SAN ONOFRE NUCLEAR GENERATING STATION, UNIT 2

AMENDMENT TO FACILITY OPERATING LICENSE

Amendment No. 32
License No. NPF-10

ATTACHMENT TO LICENSE AMENDMENT NO. 32

FIGURE 3.2-1 CYCLE I DNBR MARGIN OPERATING LIMIT BASED ON COLSS.

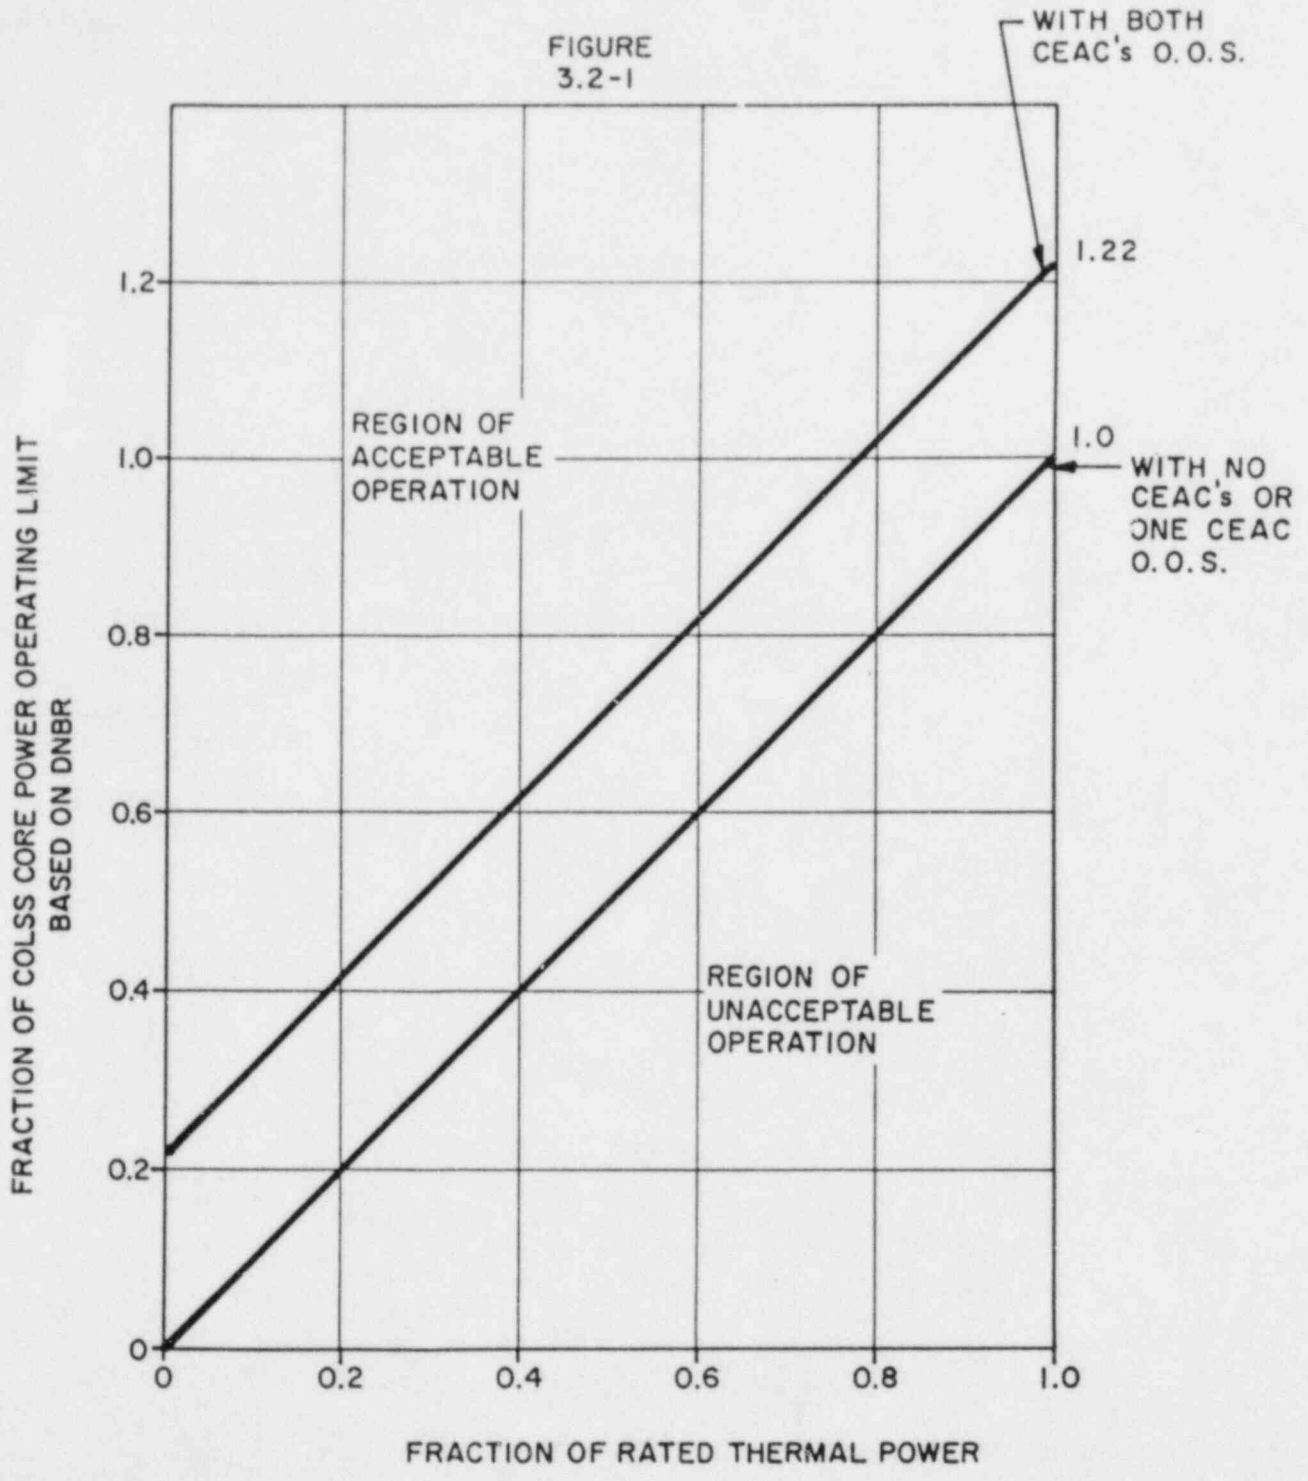
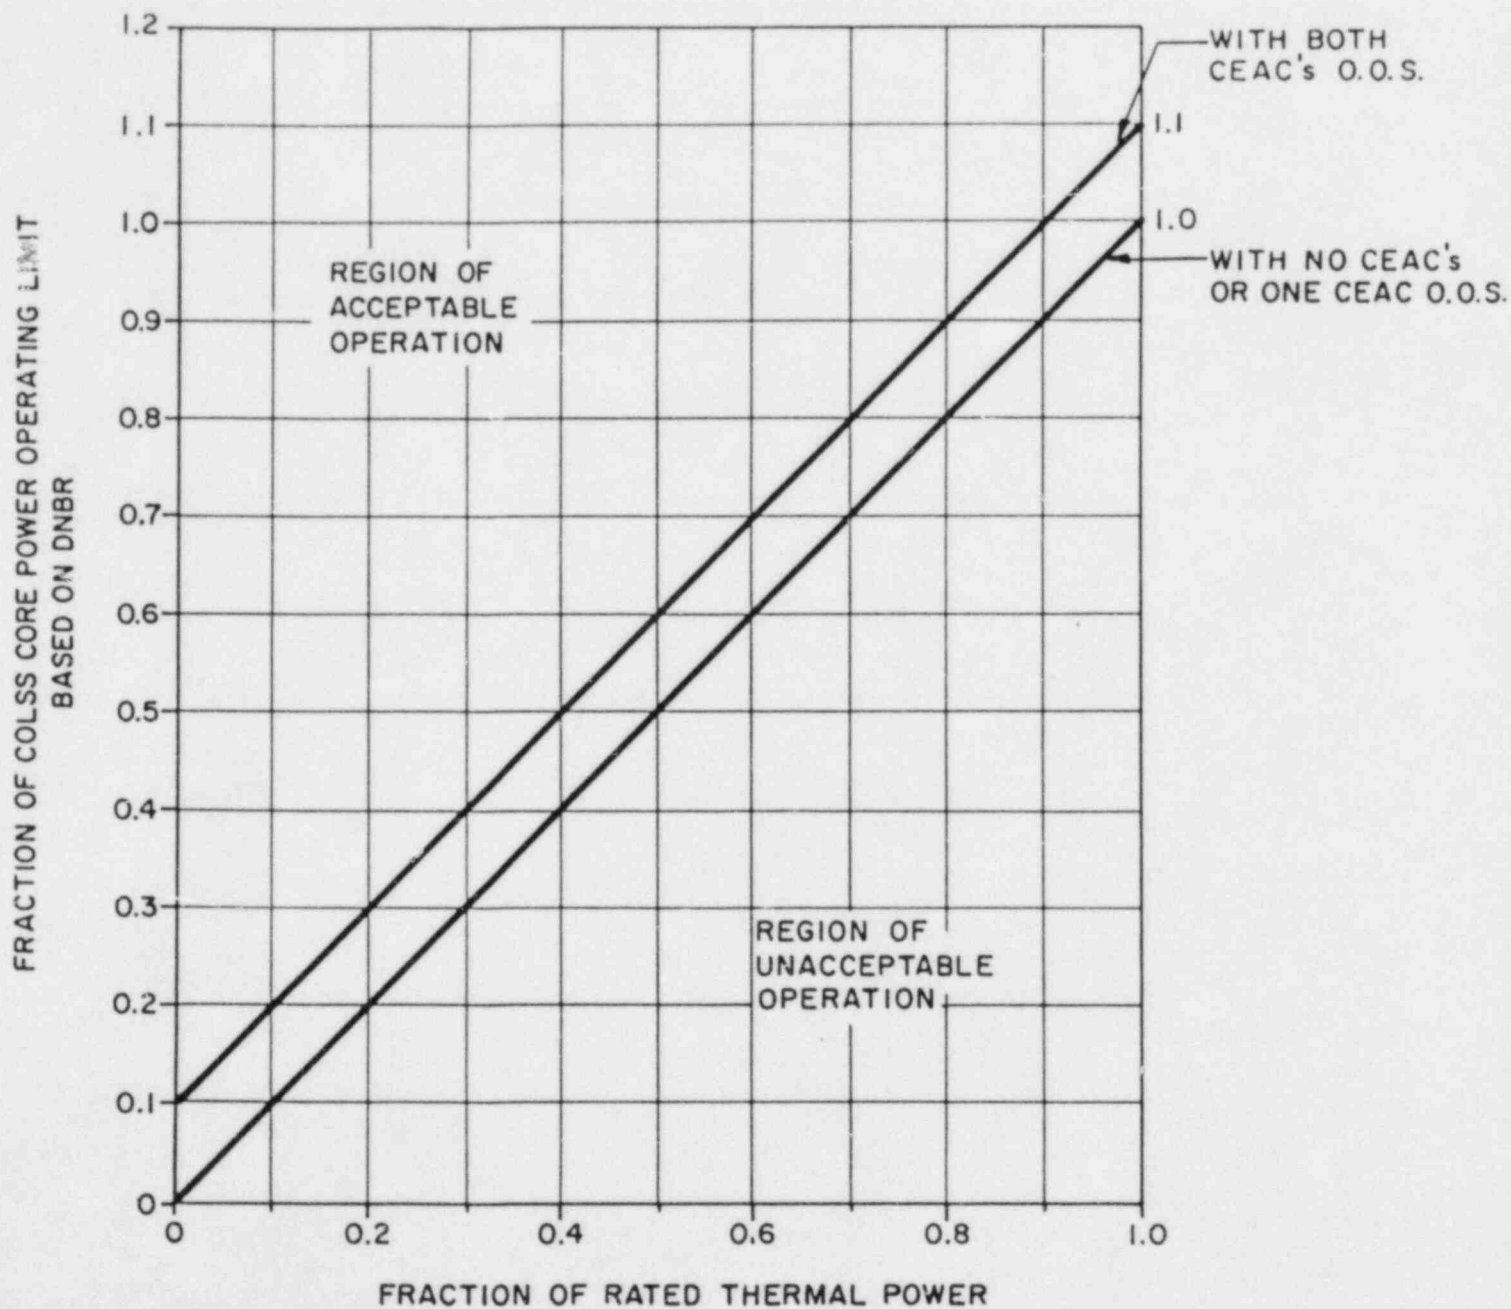
3.2.4 The DNBR margin shall be maintained by operating within the region of acceptable operation of Figure 3.2-1, 3.2-2, or 3.2-3, as applicable.

4.2.4.2 The DNBR shall be determined to be within its limits when THERMAL POWER is above 20% of RATED THERMAL POWER by continuously monitoring the core power distribution with the Core Operating Limit Supervisory System (COLSS) or, with the COLSS out of service, by verifying at least once per 2 hours that the DNBR, as indicated on all OPERABLE DNBR channels, is within the limit shown on Figure 3.2-2 or 3.2-3, whichever is applicable and the conditions of Table 3.3-2b are satisfied.

FIGURE 3.2-2 DNBR MARGIN OPERATING LIMIT BASED ON CORE PROTECTION CALCULATORS (CYCLE I, COLSS OUT OF SERVICE, WITH RATED THERMAL POWER \geq 80%)

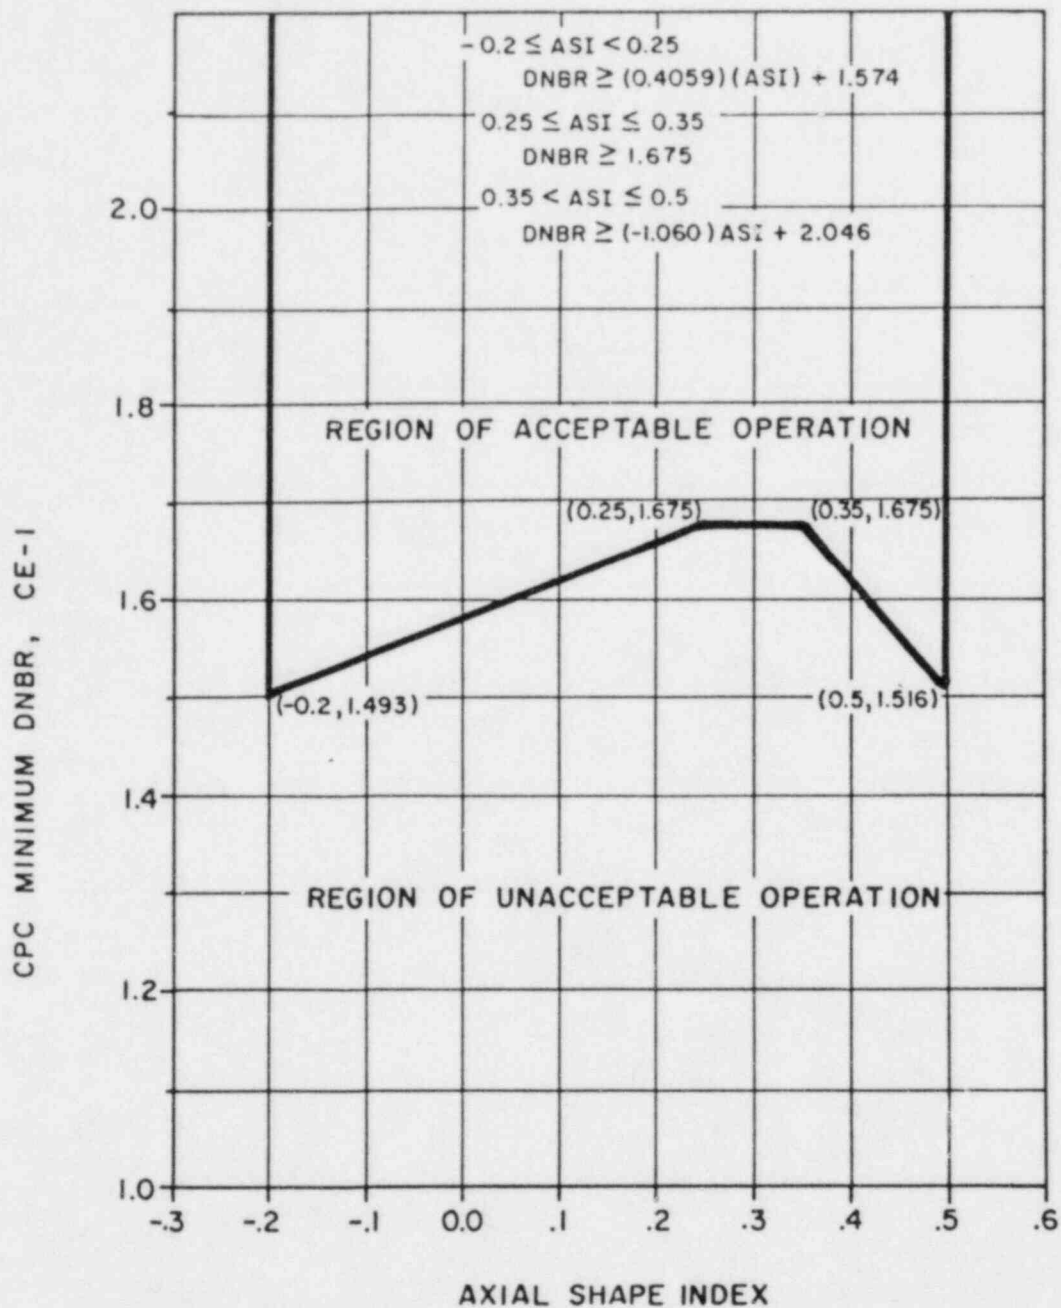
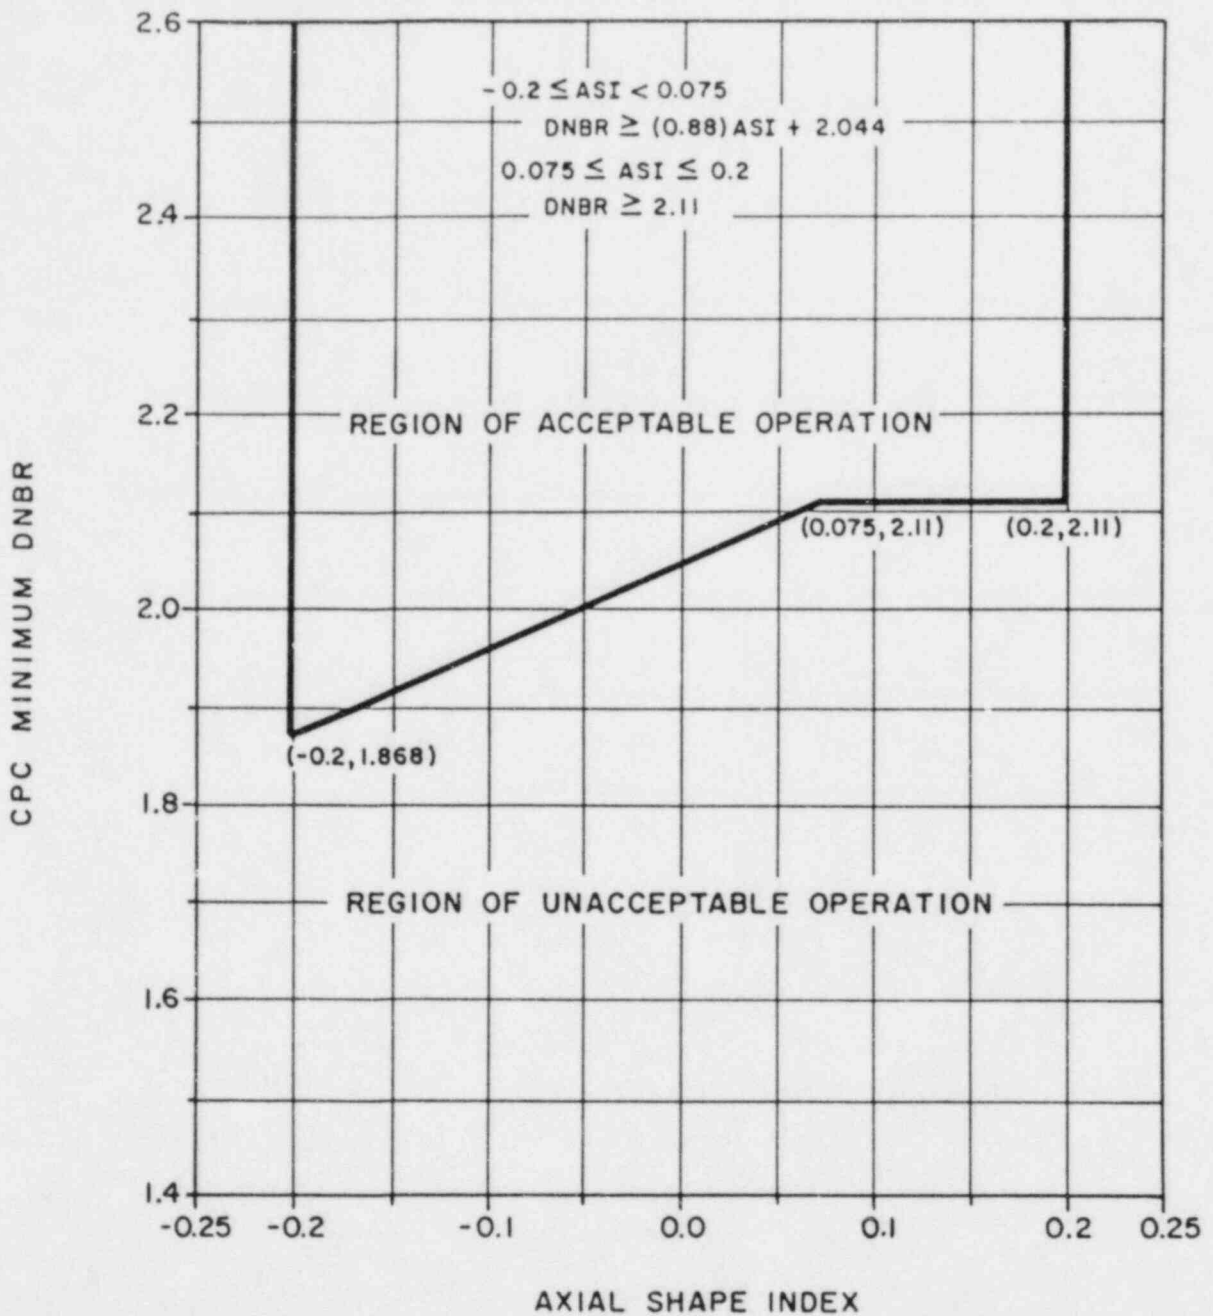
Parameters required to maintain the margin to DNB and total core power are also monitored by the CPCs. Therefore, in the event that the COLSS is not being used, operation within the limits of Figure 3.2-2 or 3.2-3 can be maintained by utilizing a predetermined DNBR as a function of AXIAL SHAPE INDEX and by monitoring the CPC trip channels. The above listed uncertainty penalty factors plus those associated with startup test acceptance criteria are also included in the CPC's which assume a minimum core power of 20% of RATED THERMAL POWER. The 20% Rated Thermal Power threshold is due to the neutron flux detector system being inaccurate below 20% core power. Core noise level at low power is too large to obtain usable detector readings. Uncertainty terms already taken into account in the CPC's safety monitoring are removed from Figures 3.2-2 and 3.2-3 since the curves are intended to monitor only the LCO during steady state operation.
